Product Change Notification

Product Group: TC/Thu Mar 3, 2022/PCN-TC-006-2021-REV-0

Carrier tape width change for TL8, B0 case

TL8, B0 case tape change Rev. 1

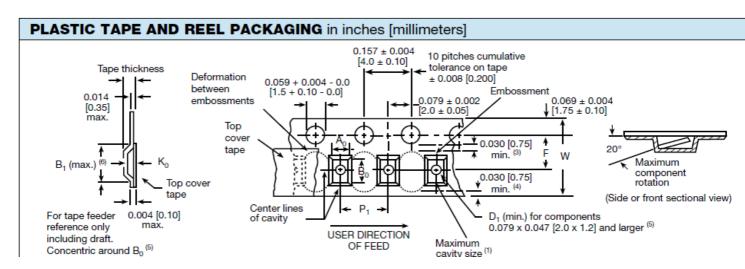
DESCRIPTION OF CHANGE: Change carrier tape width from 12mm to 8mm for TL8, B0 case capacitors

CARRIER TAPE DIME	IER TAPE DIMENSIONS in inches [millimeters] FOR TL8, CASE CODE B0								
TAPE	TAPE WIDTH	B1 (MAX)	D1 (MIN)	F	K0 (MAX)	P1	W		
CURRENTLY USED	12mm	0.181 [4.61]	0.059 [1.5]	0.217 [5.5]	0.049 [1.25]	0.157 [4.0]	0.472 [12.0]		
PROPOSED (NEW)	8mm	0.157 [4.0]	0.039 [1.0]	0.138 [3.5]	0.057 [1.45]	0.157 [4.0]	0.315 [8.0]
